# CHABOT-LAS POSITAS COMMUNITY COLLEGE DISTRICT PURCHASING DEPARTMENT

## Addendum No. 2

### REQUEST FOR PROPOSAL BID: B23/24-06 Erosion Control Project at Las Positas College

SHEET **C5.0** OF SHEETS

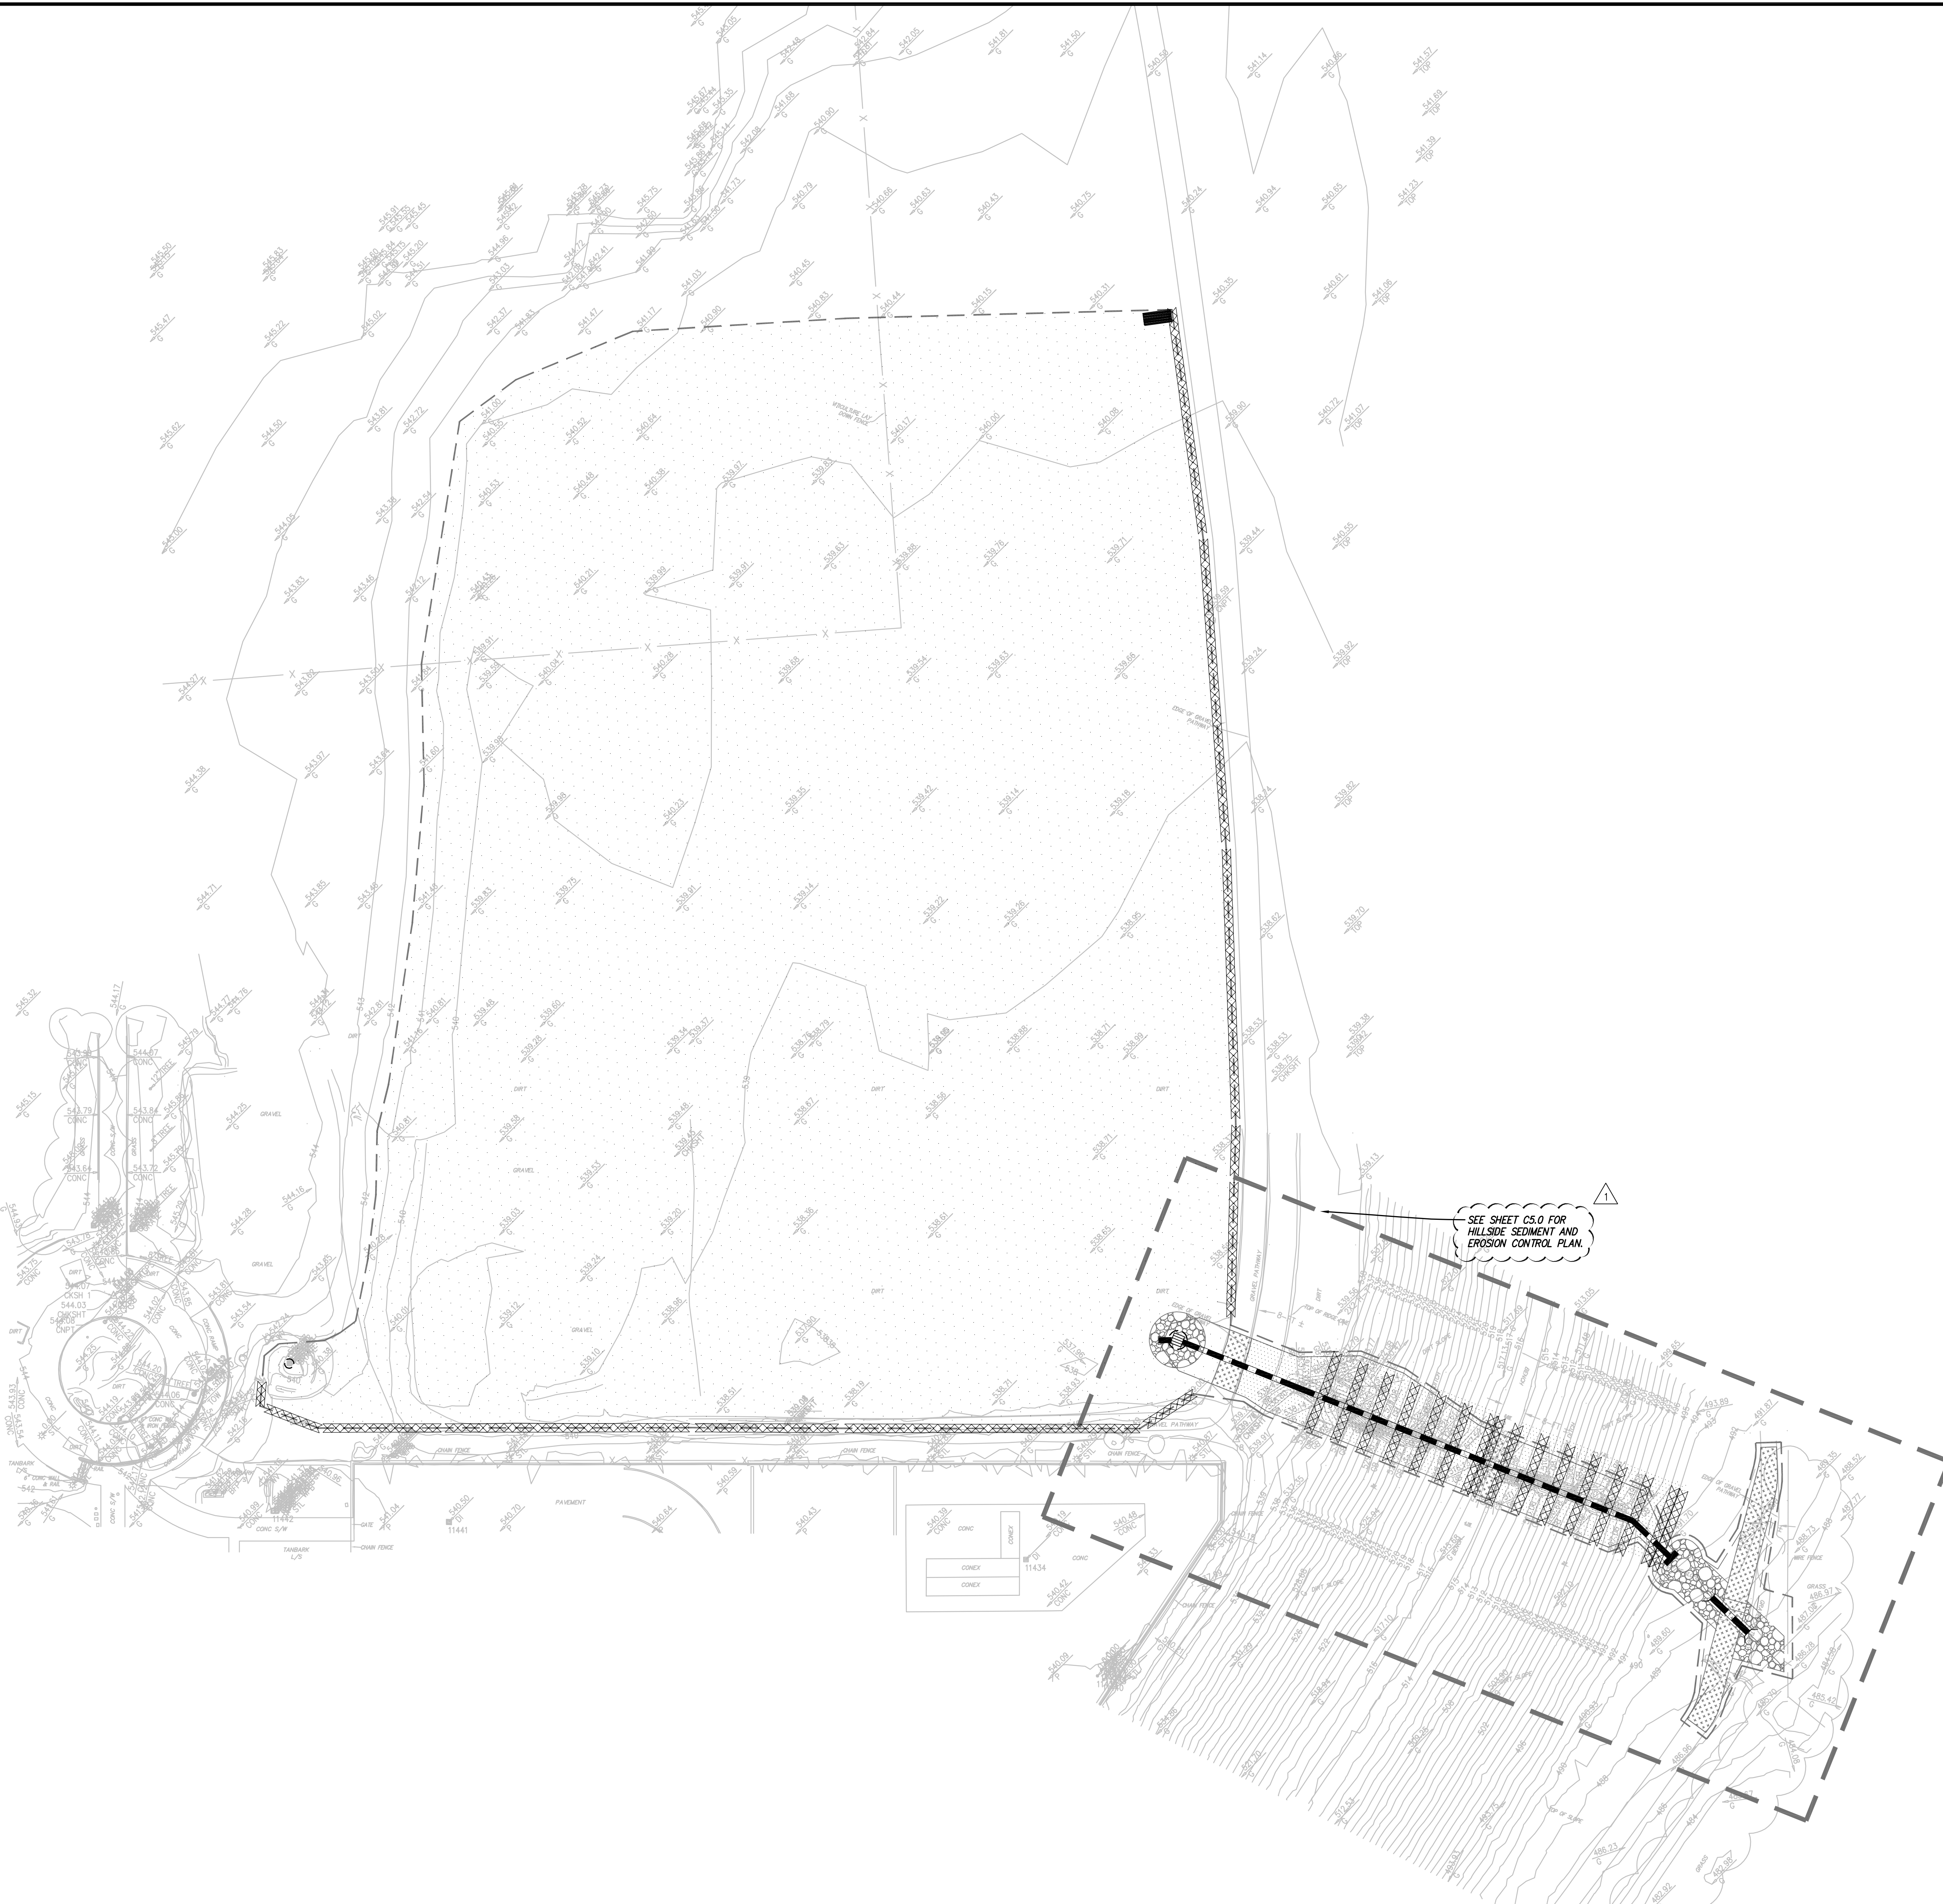
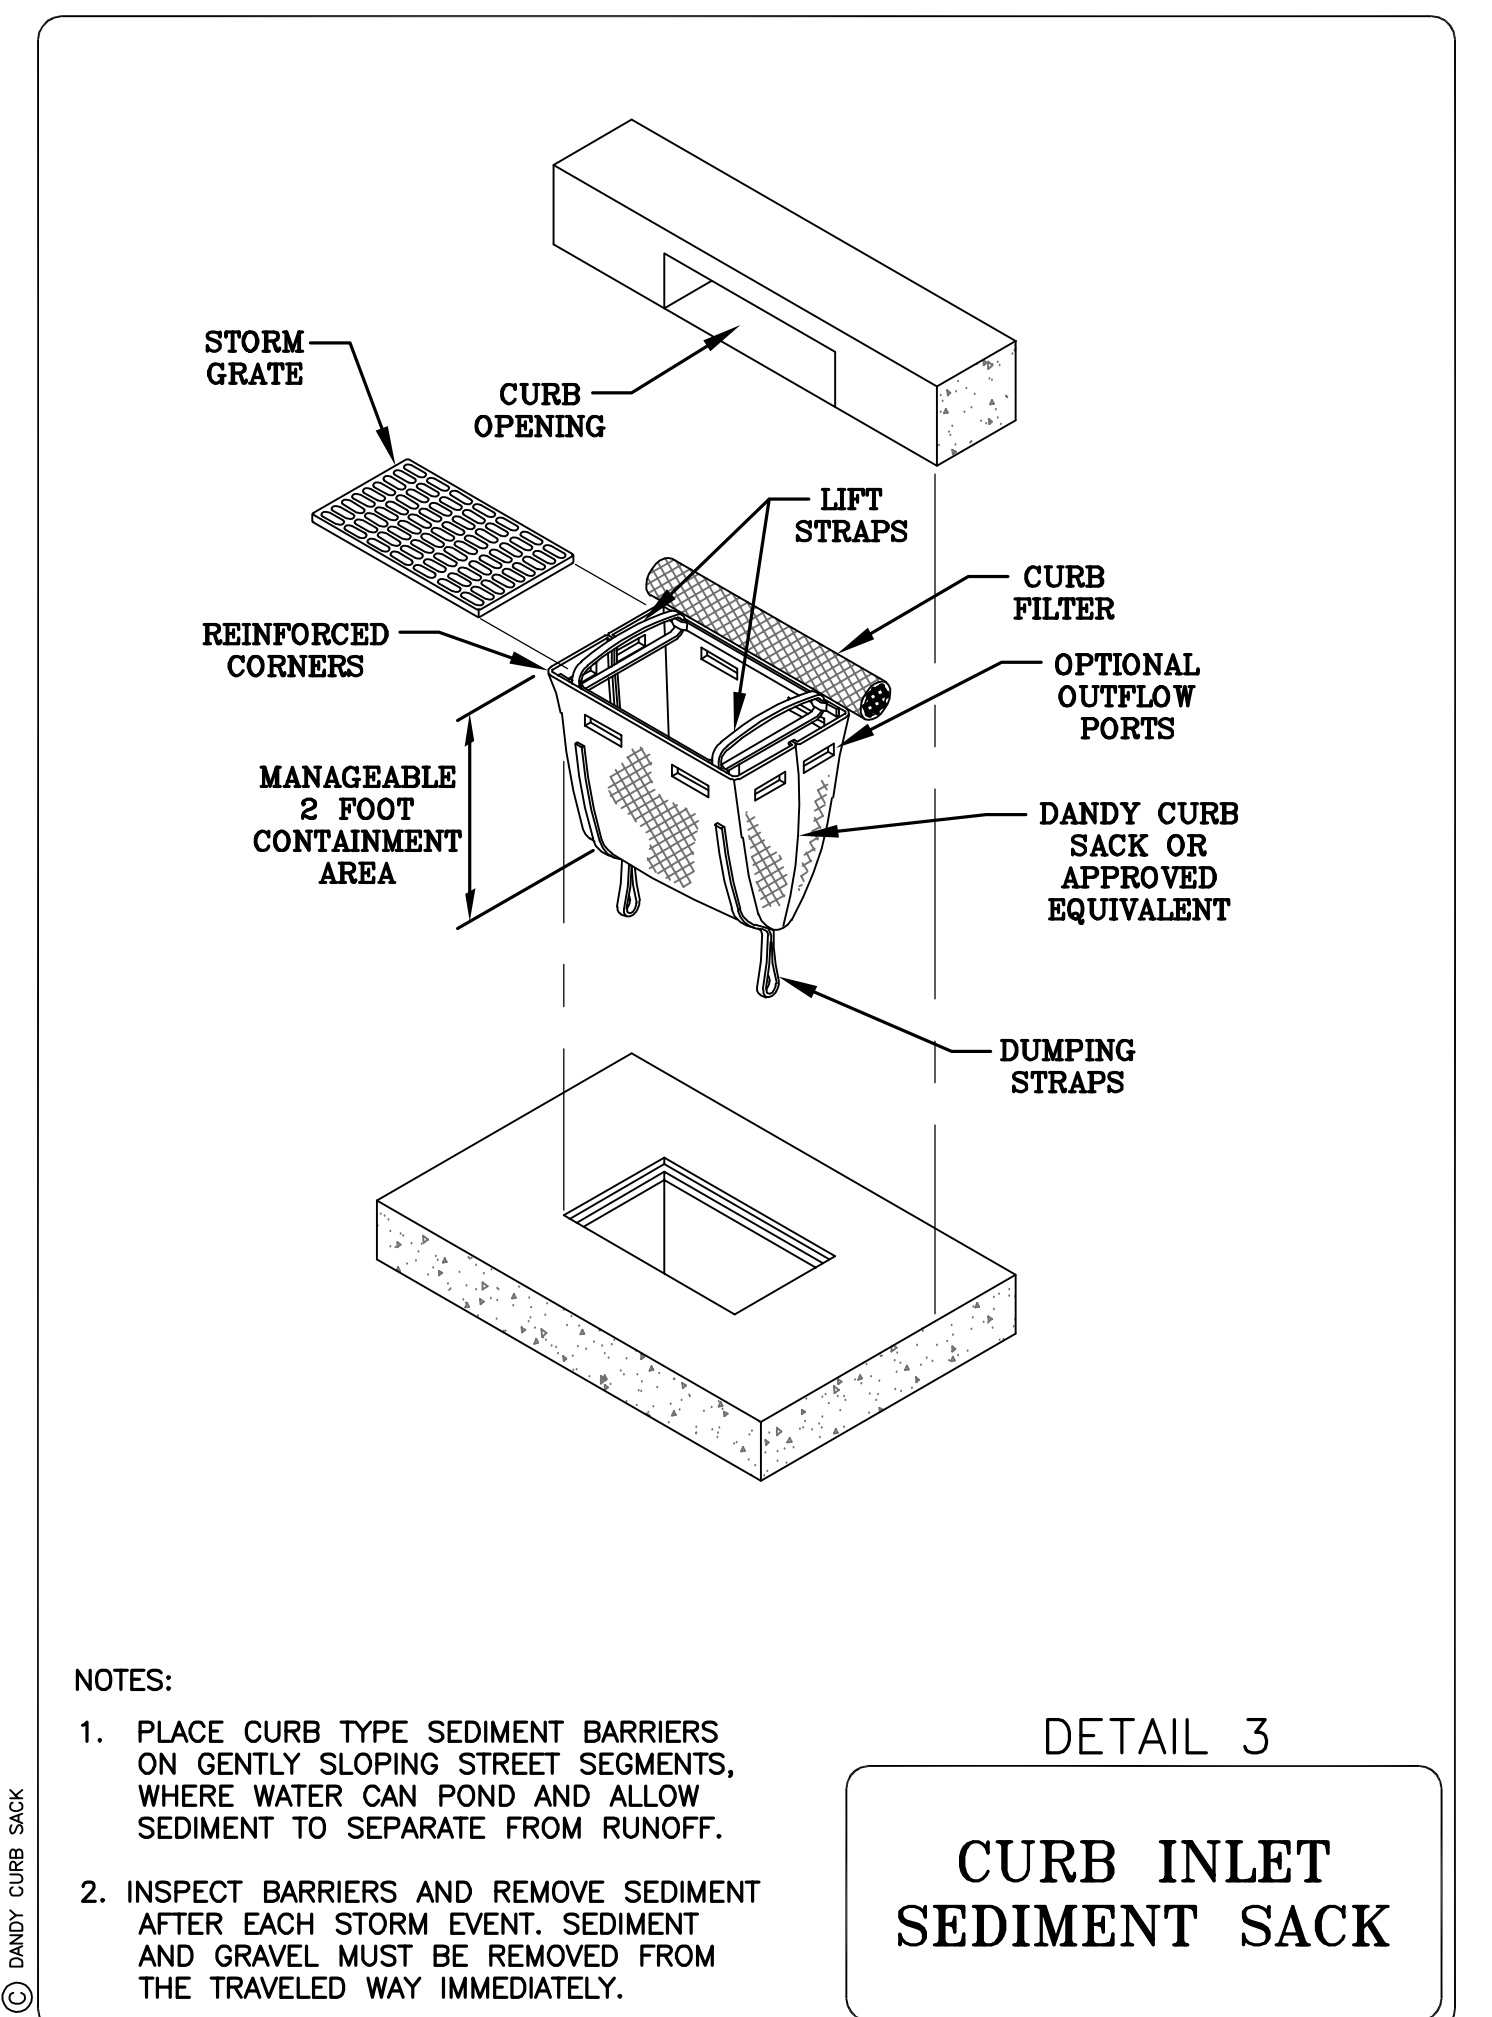
**Question No. 22:** The shading for hydroseed areas is a "+" sign. In my opinion, there are 3 different styles of "+" on these sheets. Two of which cover the gravel roads we are to install per the plans. Can you please clarify the actual areas to be hydroseeded?

**RESPONSE:** Gravel roads are not intended to be hydroseeded. See revised sheets C5.0 and C5.1 attached to this addenda 2.
